Victoria Quarter

Save New Barnet

Response to Planning Application 20/1719/FUL

June 2020

Figure 5.1: Noise Monitoring Locations

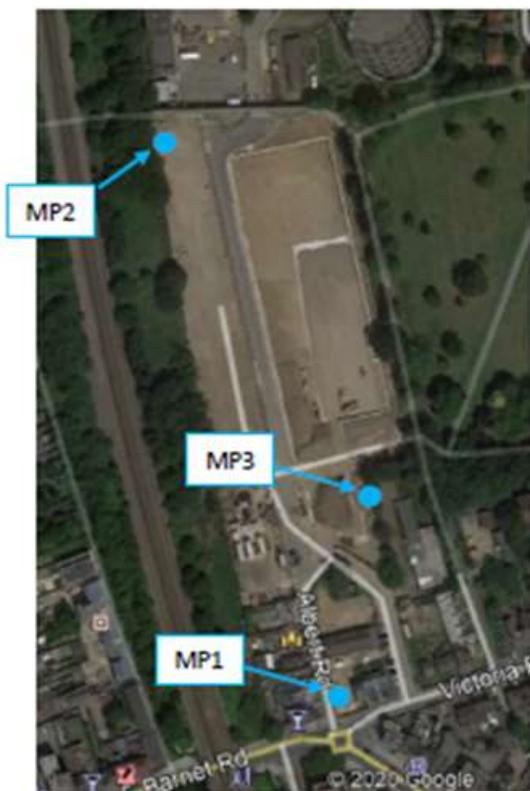
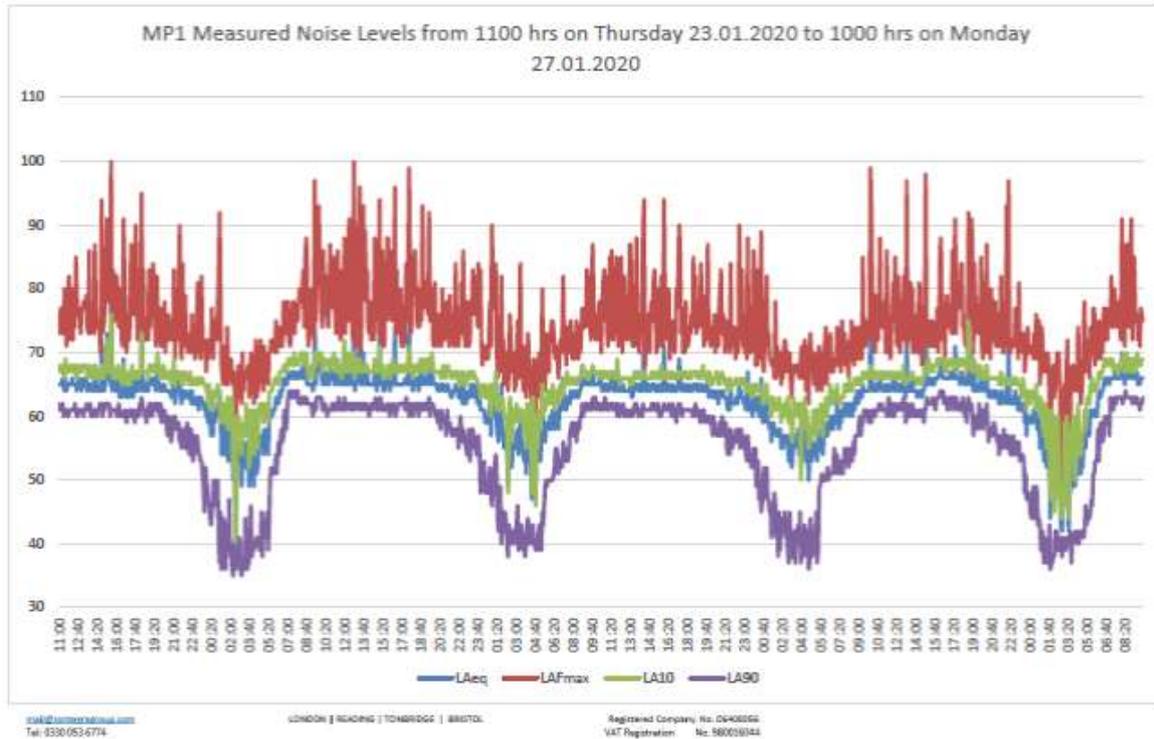
The chart for site MP1 showed readings as high as 100 Db although the average seemed to be around 65-70 Db.

The report concludes that this is due to road noise from East Barnet Road and hence why they need to focus on the front blocks for noise insulation. The readings, taken at the back of the site, show quite modest noise levels, supporting their assumption that it is road noise. We then reviewed the location of the noise detectors. The MP1 detector at the front of the site was located “in a free-field location at a **height of 4.5m** on the corner of Albert Road and Victoria Way, approximately 10m from the junction of Victoria Way and the A110 East Barnet Road. MP1 was also approximately 14m from a plant area of The Railway Bell Public House, located on a first floor flat roof area adjacent to Albert Road. The position was chosen to capture road traffic noise levels at the worst affected part of the site, as well

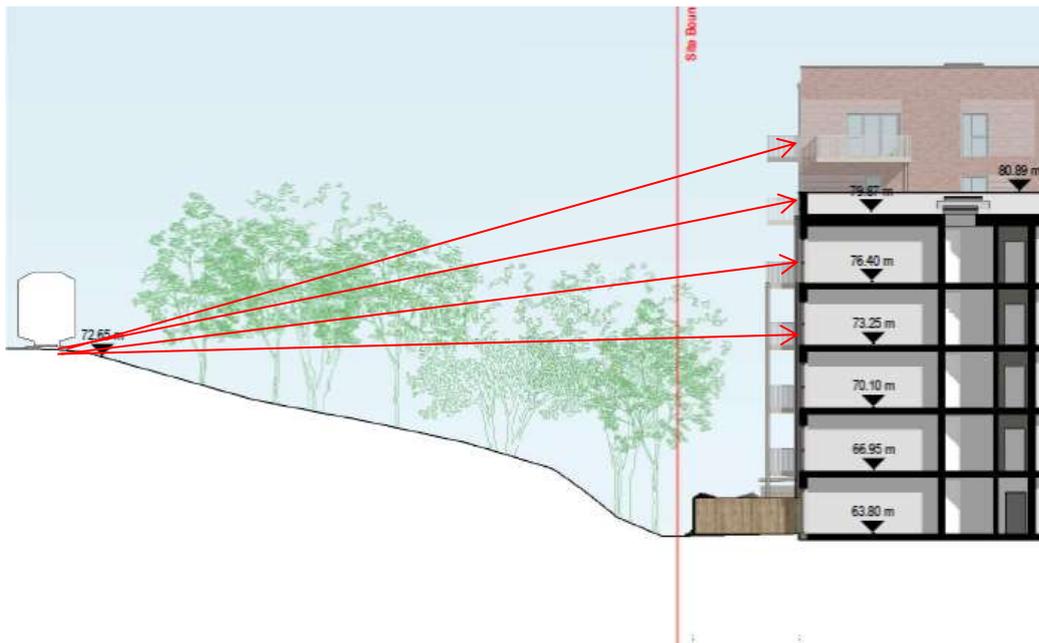
The MP2 detector is close to the railway line “located in a free-field location at a **height of 1.5m** approximately 5m back from the western boundary of the site (approximately 35m from the closest tracks of the railway line) and approximately 15m from the northern boundary of the site. The position was chosen to capture noise levels from the railway and any activity noise from the Albert Road Gas Works”.

Critically, at that point on the site (which we have marked in red) there is a lot of foliage on the embankment, so at a height of 1.5m and close to the boundary where all the foliage is present, the detector would be effectively screened from railway noise.

By comparison the 4.5m height of the MP1 detector would expose it much more to the railway noise considering the bridge clearance is the same, 4.5 metres. Indeed, reviewing Rail Safety & Standards Board code of practice for measuring noise identifies the optimal height for sound measurement is 1.5m to 3.5m above the height of the rails, not above ground level.

We would ask that the noise report is reviewed and noise measurements taken again at an appropriate height to ensure that a suitable noise mitigation strategy is developed.

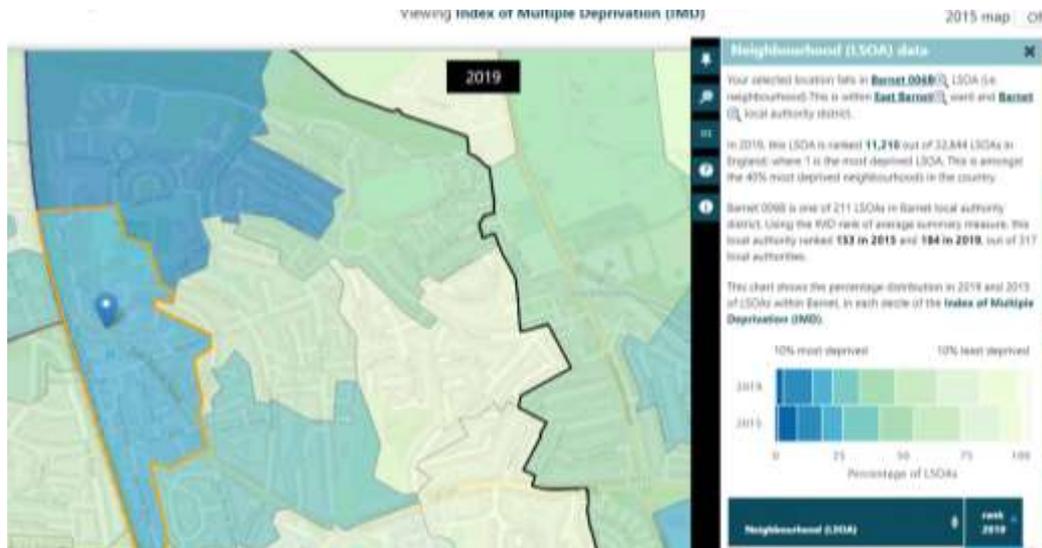
In some residential blocks that face a major railway line like this, elevations are often designed as blank facades, possibly with small windows for bathrooms or kitchens. An example of this is the flats adjacent to New Barnet Railway station.

This is possible if the corridor is single loaded. However, in the blocks facing the railway line, the corridors are double loaded and as such, there are 110 flats which contain habitable rooms facing the railway.
